# UNITED STATES PATENT AND TRADEMARK OFFICE

APPLICATION NO.	FILING DATE	FIRST NAMED INVENTOR	ATTORNEY DOCKET NO.	CONFIRMATION NO.
10/020,314	12/18/2001	Yasuhiro Shimamoto	HITA.0143	8410
38327	7590	02/10/2006	EXAMINER	
REED SMITH LLP 3110 FAIRVIEW PARK DRIVE, SUITE 1400 FALLS CHURCH, VA 22042			NGUYEN, KHIEM D	
			ART UNIT	PAPER NUMBER
			2823

**Remail**  
**Office Action Summary**

## DETAILED ACTION

**Fig. 8**

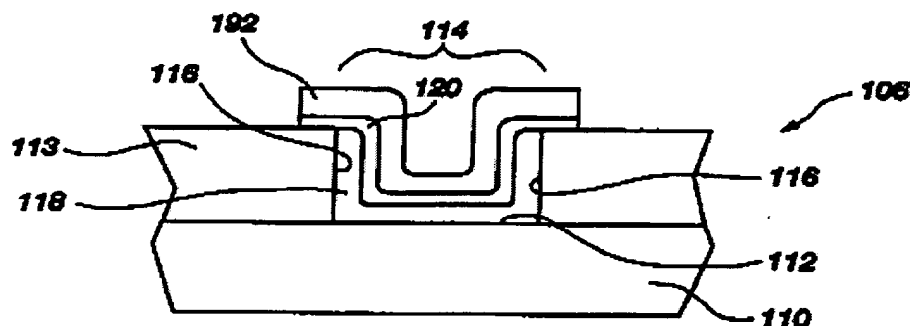
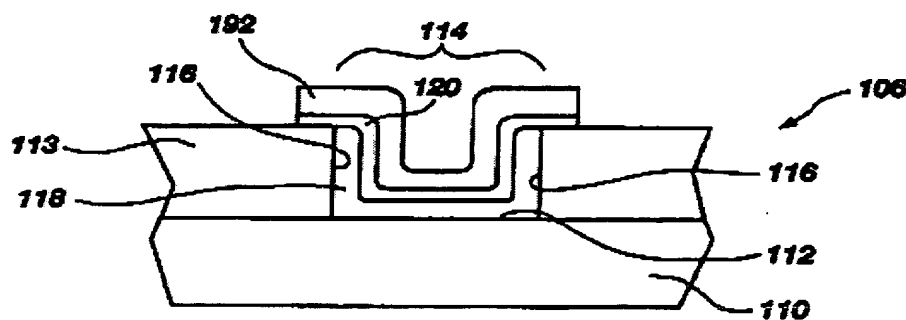
In re claim 1, **Marsh** discloses a fabricating method of a semiconductor integrated circuit device **106** comprising forming a bottom electrode **118** (col. 10, lines 39-62) of a capacitor with high-k material on a semiconductor substrate **110** by a chemical vapor deposition method in a sub-atmospheric pressure using an organoruthenium compound as a precursor (col. 7, lines 50-67 and FIG. 8), which includes steps of:

separately supplying the precursor and an oxidation gas into the deposition chamber to form a ruthenium film for the bottom electrode with a desired thickness on the heated semiconductor substrate, the oxidation gas being separately supplied to the deposition chamber by a supplying system different from a precursor supplying system and only during when the precursor being supplied (col. 7, line 50 to col. 8, line 61); and

stopping the supply of the precursor and the oxidation gas and decreasing the temperature of the semiconductor substrate, wherein the bottom electrode essentially consists of ruthenium (col. 8, lines 23-46).

In re claim 21, Marsh discloses a fabricating method of a semiconductor integrated circuit device 106 comprising forming a top electrode 192 (col. 10, lines 39-62) of a capacitor with high-k material on a semiconductor substrate 110 by a chemical vapor deposition method in a sub-atmospheric pressure using an organoruthenium compound as a precursor (col. 7, lines 50-67 and FIG. 8), which includes steps of:

separately supplying the precursor and an oxidation gas into the deposition chamber to form a ruthenium film for the top electrode with a desired thickness on the heated semiconductor substrate, the oxidation gas being separately supplied to the deposition chamber by a supplying system different from a precursor supplying system (col. 7, line 50 to col. 8, line 61); and

stopping the supply of the precursor and the oxidation gas; and decreasing the temperature of the semiconductor substrate, wherein the top electrode essentially consists of ruthenium (col. 8, lines 23-46), and the oxidation gas is supplied to the deposition chamber when the substrate temperature is increased, when the precursor is supplied, and when the substrate temperature is decreased (col. 7, line 62 to col. 8, line 40).
